ADDENDUM NO. 1

PROJECT: Freezout Lake WMA Flume Replacement

FWP PROJECT #: 7135313

DATE: 8/14/15

SHEET: 6 of 6

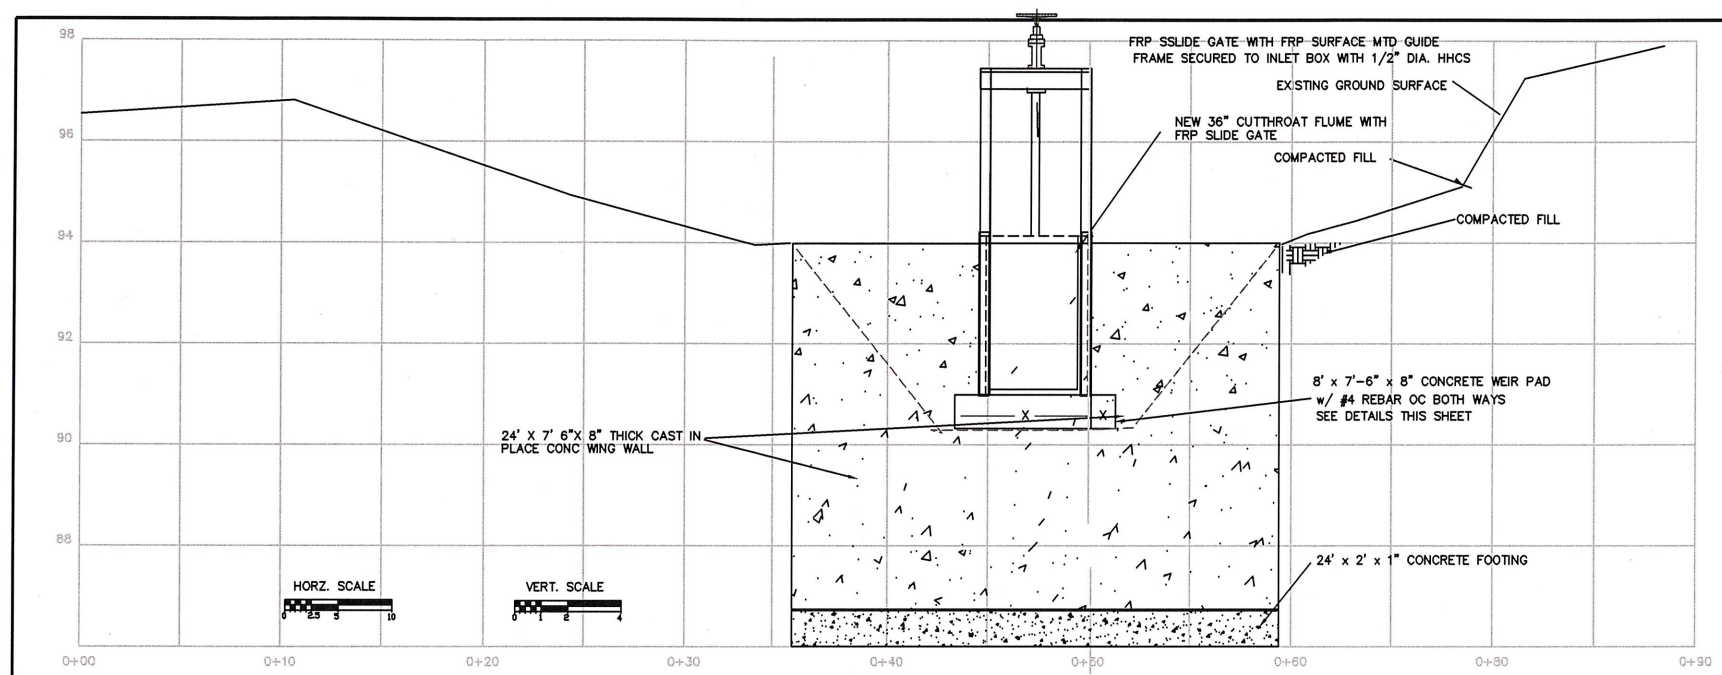
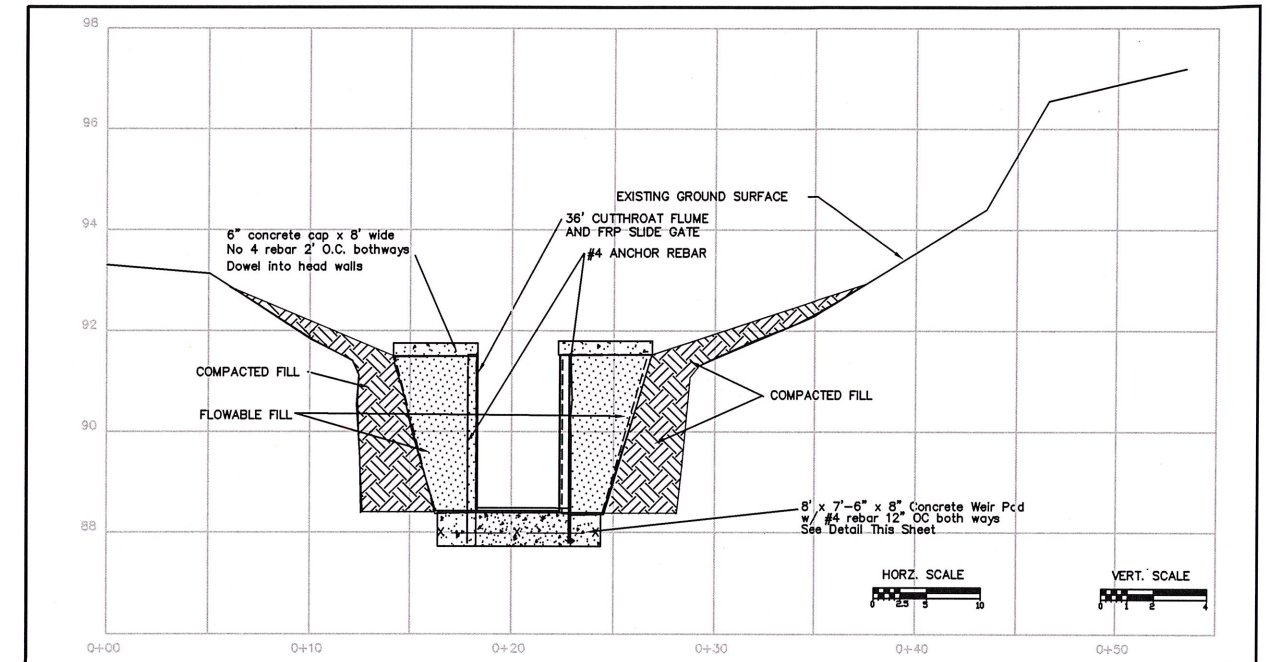
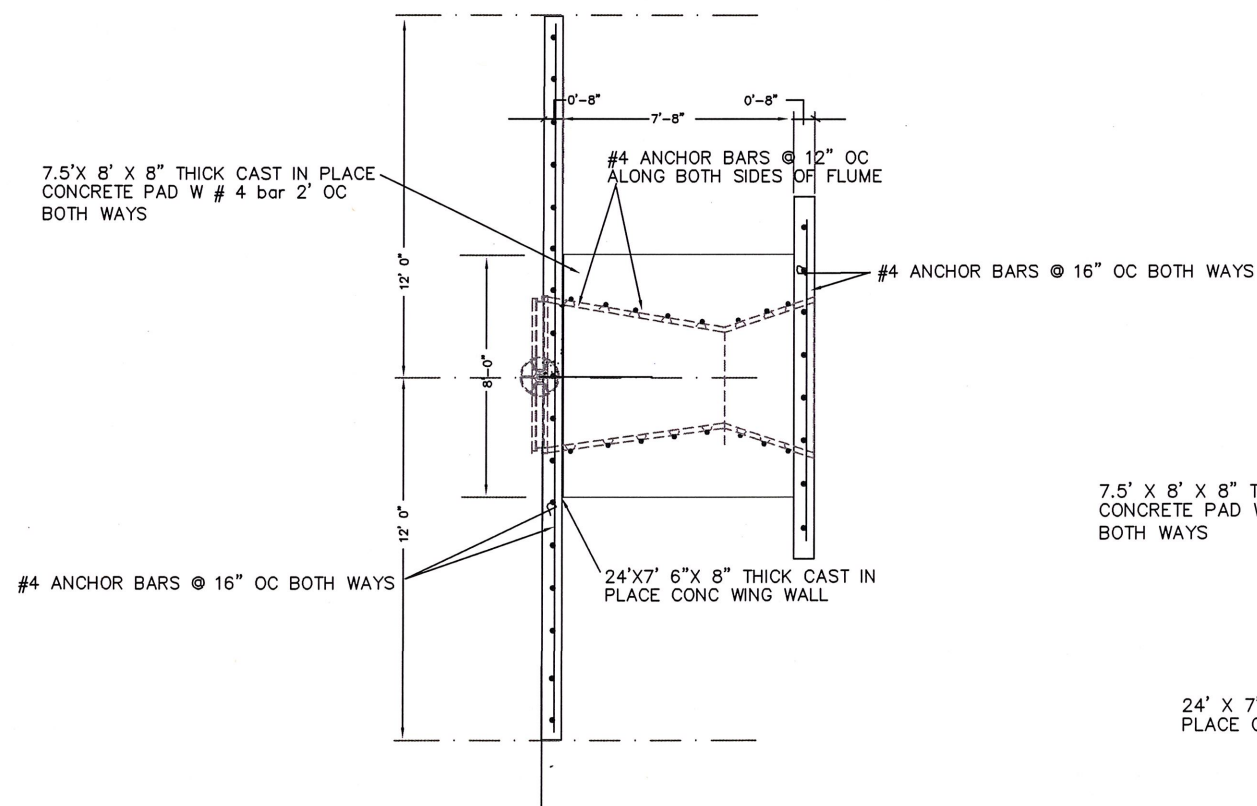
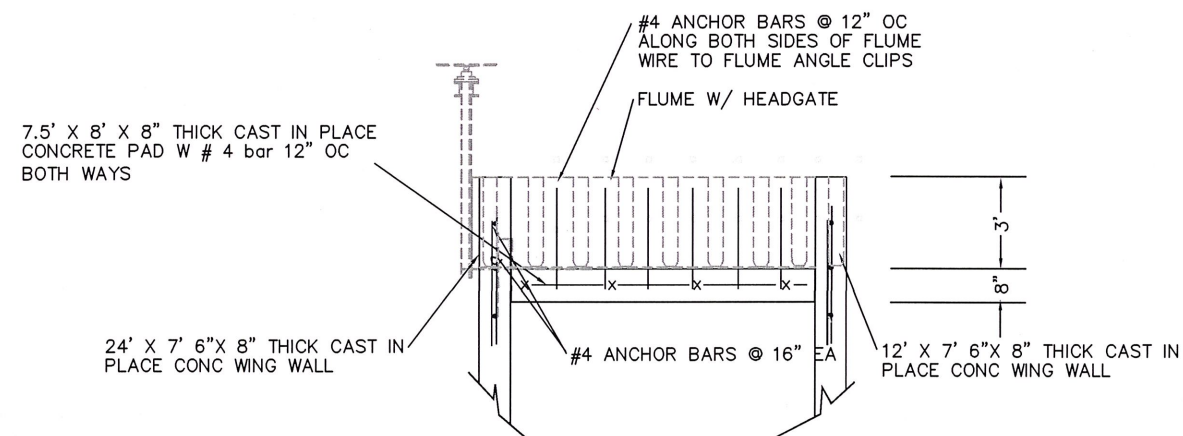
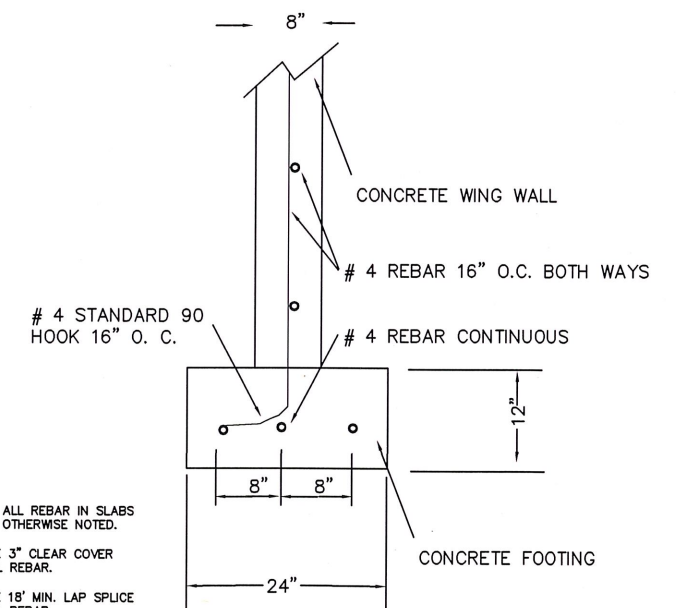
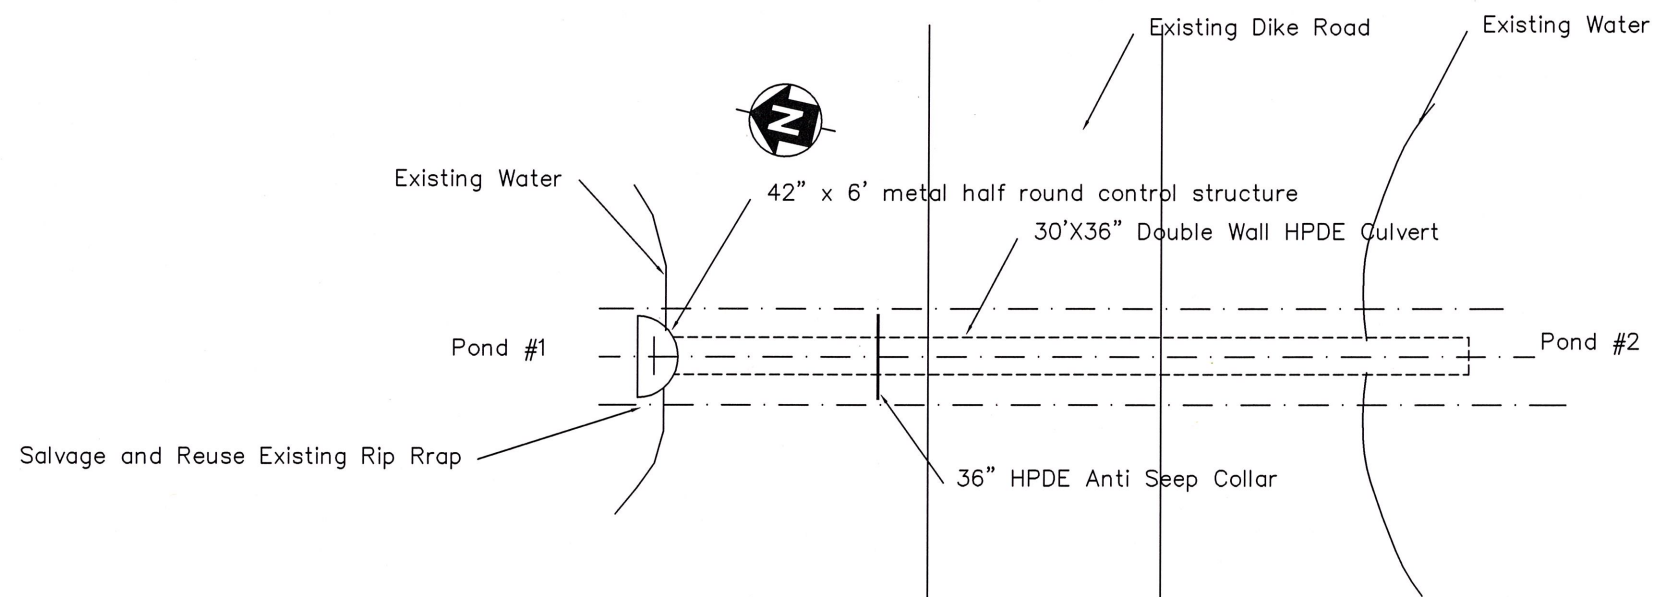
1. Bidders shall use new updated Bid proposal form to submit bids
2. Section 13630 Fiberglass Flume 2.1A.is amended to add 5. Cut Throat Flume shall include an 8" molded stilling well.
3. Plan sheets 2, 5 and 6 have been modified to adjust the Flume installation elevation and increase the headwall heights please use the new sheets #2, #5 and #6 for bidding.
4. Addendum plan sheet #1 has been added for the replacement of an existing half round water control structure and 30' 36" HPDE. This structure and pipe **must be installed prior to October 3, 2015**. The new half round structure shall be (42" 1/2 rnd @ 6' w/smooth 36" outlet to fit 36" HDPE) ID as manufactured by TrueNorth Steel, Inc 1501 S 30th St W Billings Montana or an approved equal.
